DPD Project # 3009397 | Design Guidance

Medical Dental Building, 2800 MLK Jr Way S., Seattle, WA

Design Guidance Response

East Elevation

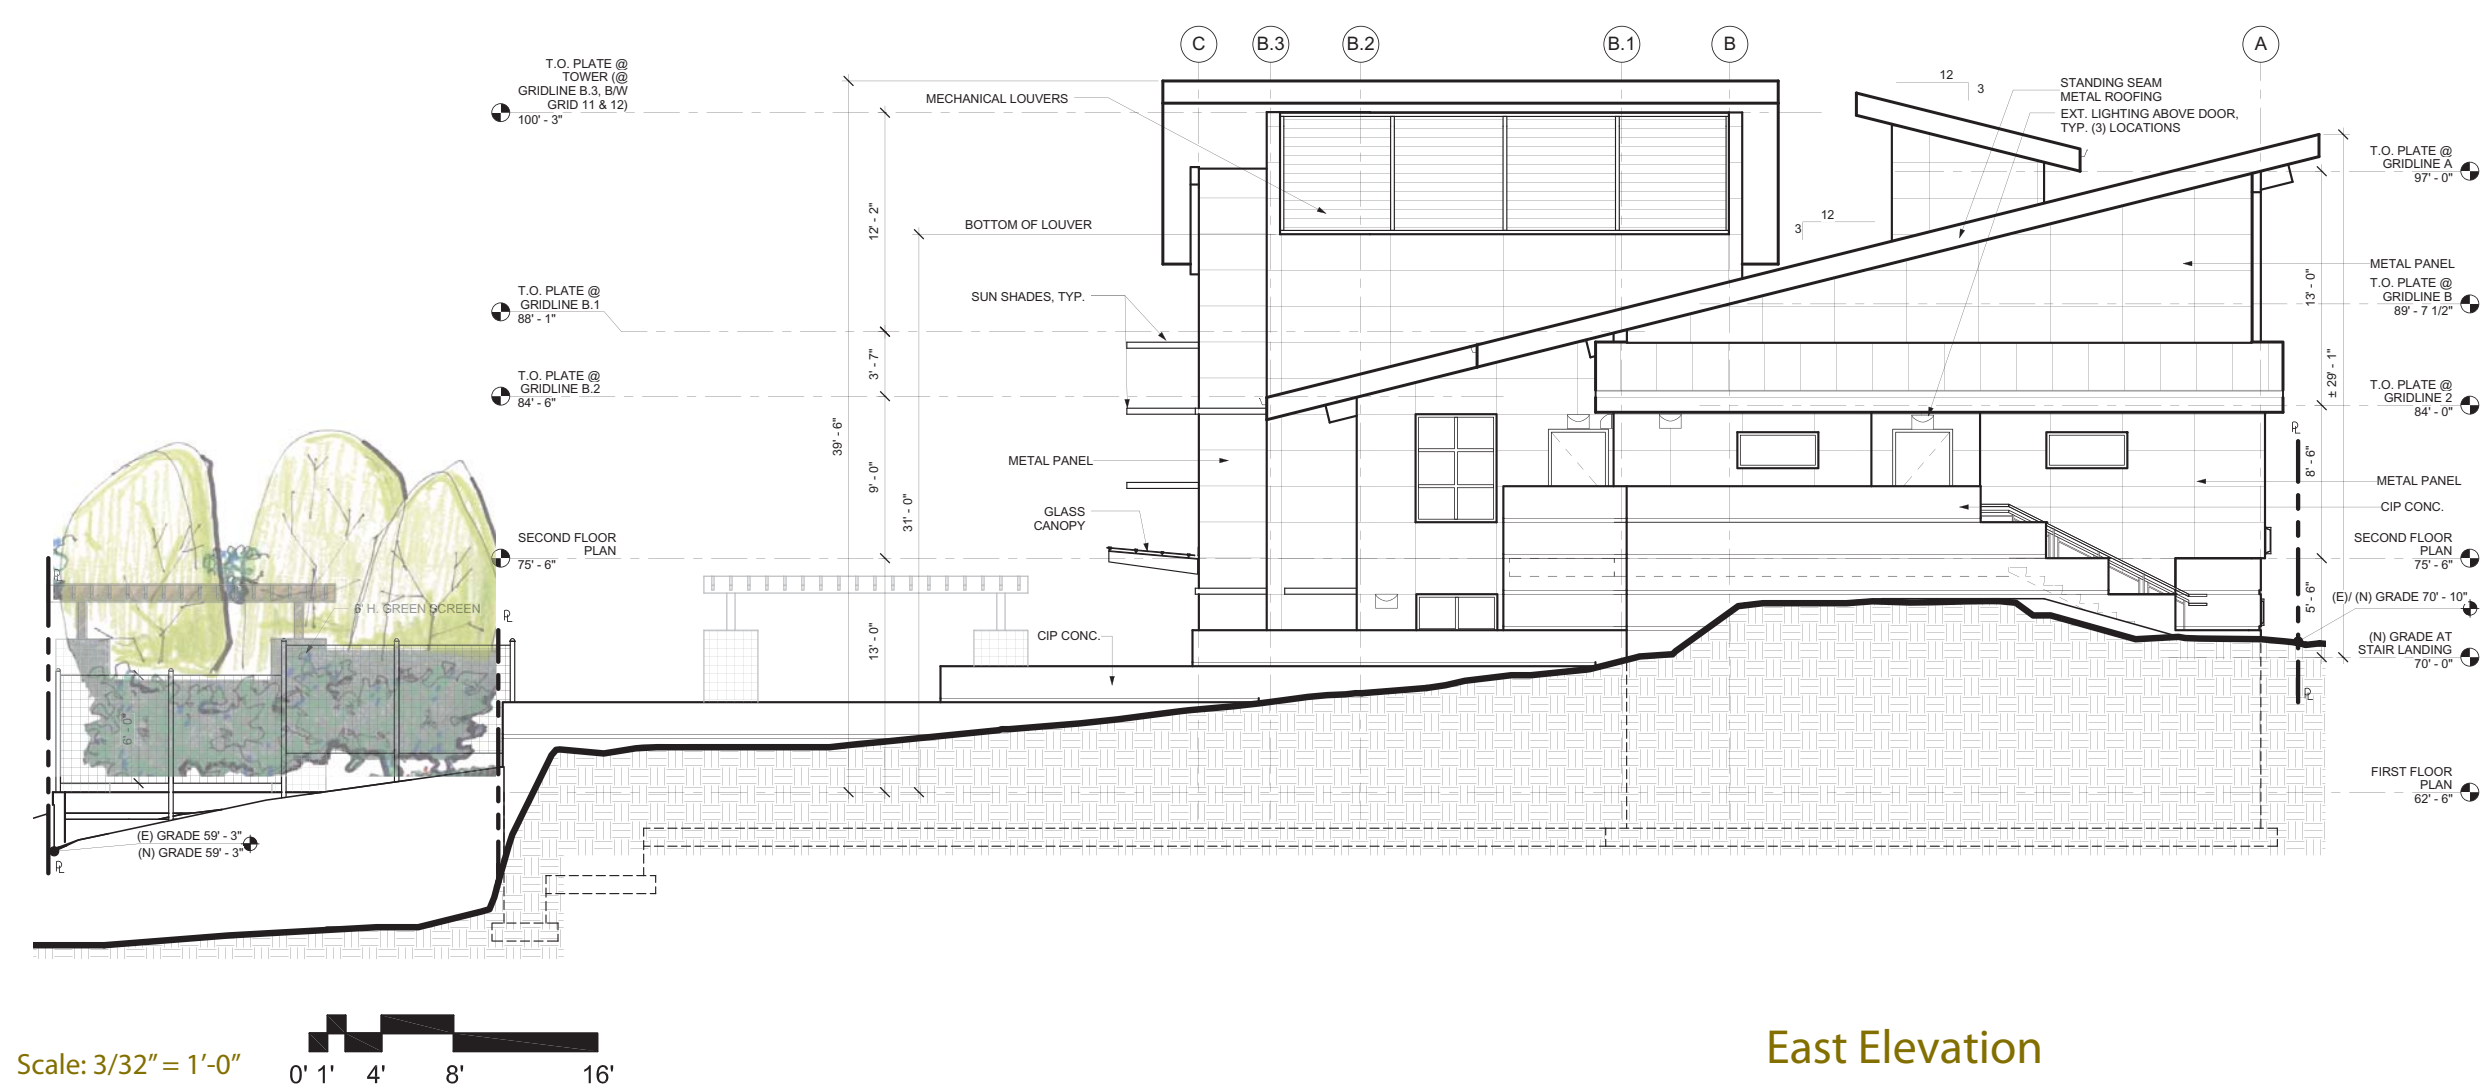
- SE corner of project site: Due to the topographic depression to the southeast of the project site, any retaining wall system and fencing will be highly visible from the properties in that direction. A suggestion is a low maintenance ornamental metal fence that would allow visibility of the adjacent parking lot landscape screening and allow solar exposure for that landscaping while not exacerbating the grade difference by a solid continuous combined retaining wall and fence.

- See sheet 14, East elevation.

Site Lighting Plan

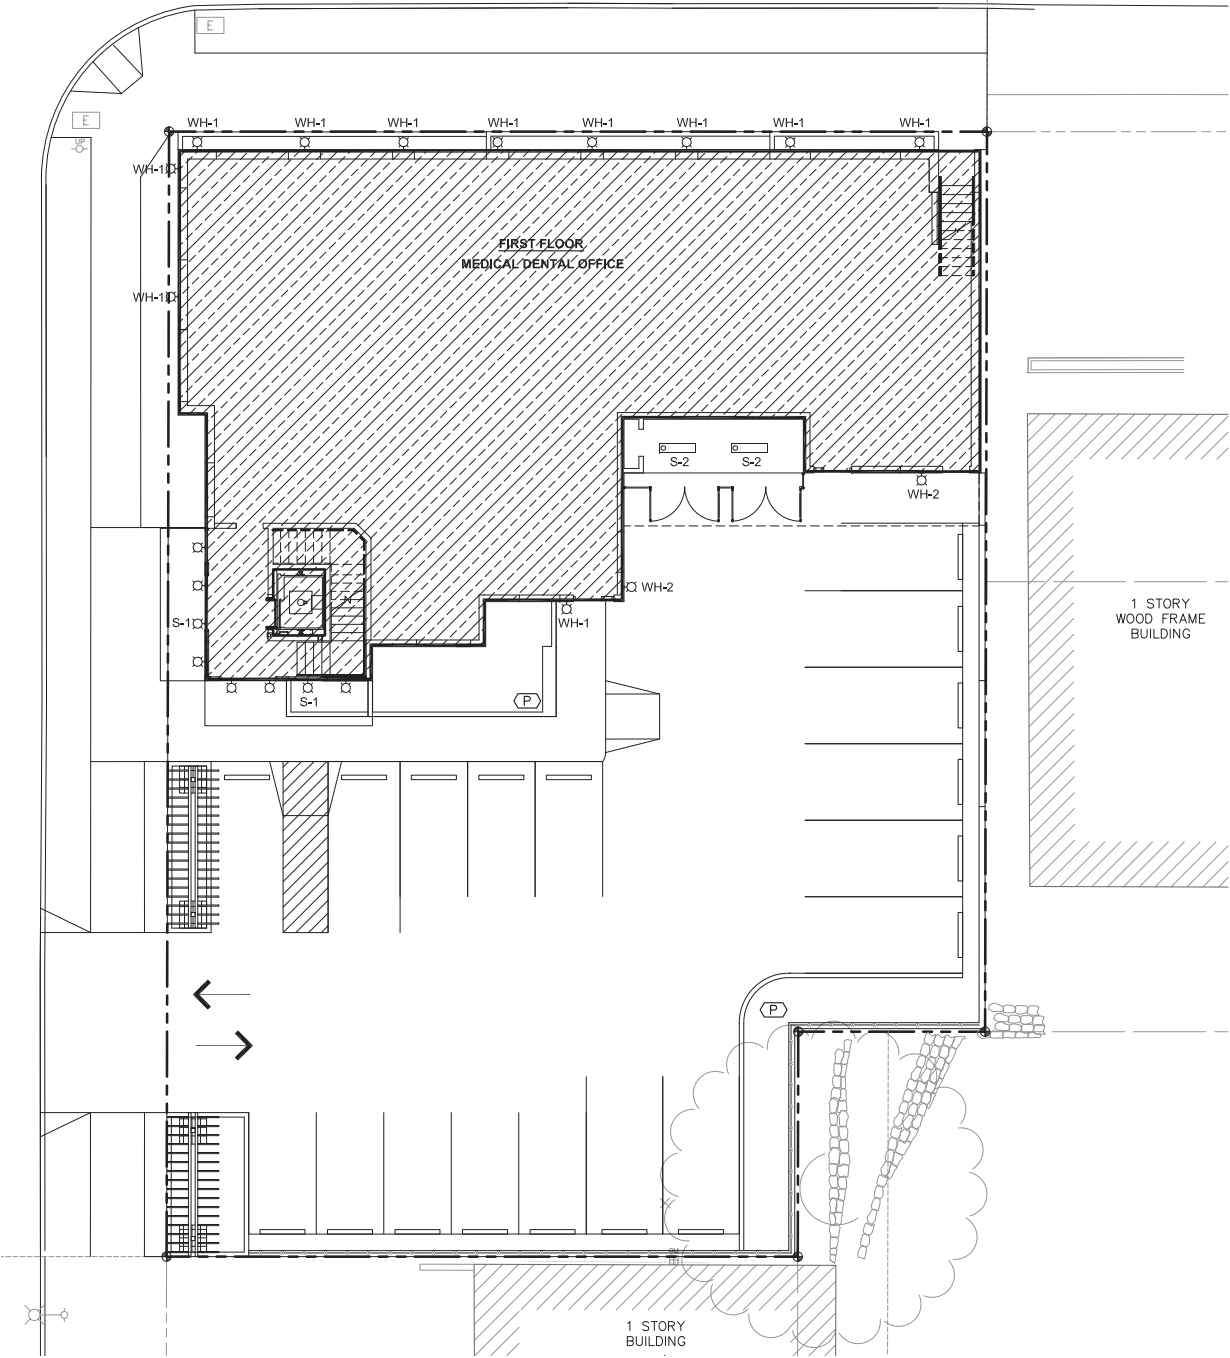
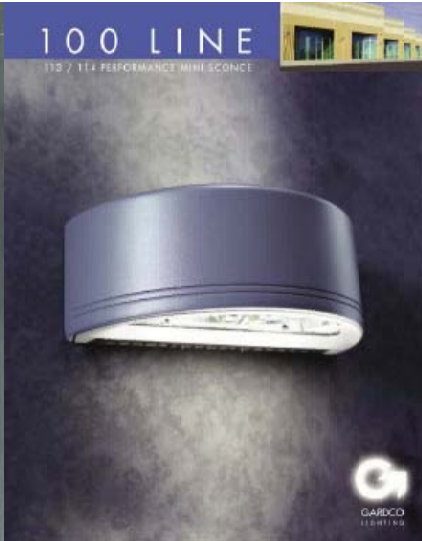
- Security lighting to address nighttime safety should not produce "light trespass" to the adjacent single-family neighborhood or to the street. Proposed approaches to lighting and security gating must be submitted with the MUP application for review by DPD and the Board.

- See sheet 19 for site lighting plans and electrical cut sheets.
